## Product Change Notification / SYST-30SUPV010

ERRATA - PIC32MK General Purpose and Motor Control (GPK/MCM) with CAN FD Family Silicon Errata

## PIC32MK General Purpose and Motor Control (GPK/MCM) with CAN FD Family Silicon Errata and Data Sheet Clarifications

### 2.2.2 VBUS pin

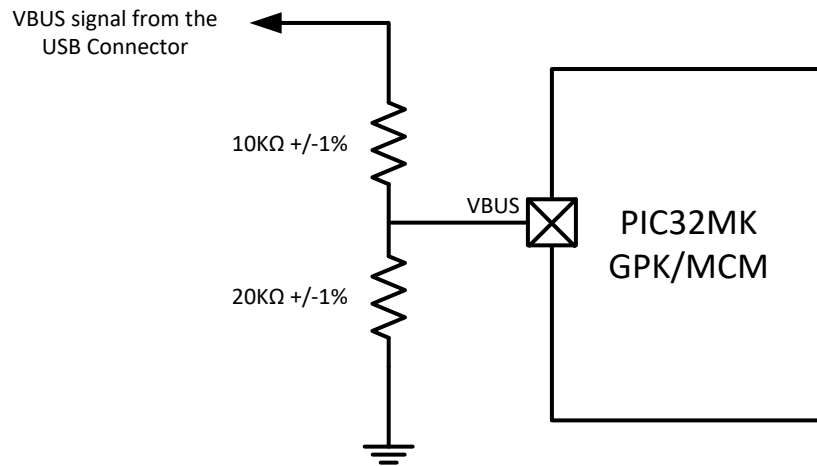
The VBUS pin is not 5V tolerant.

Connect an external voltage divider as shown in the following figure:
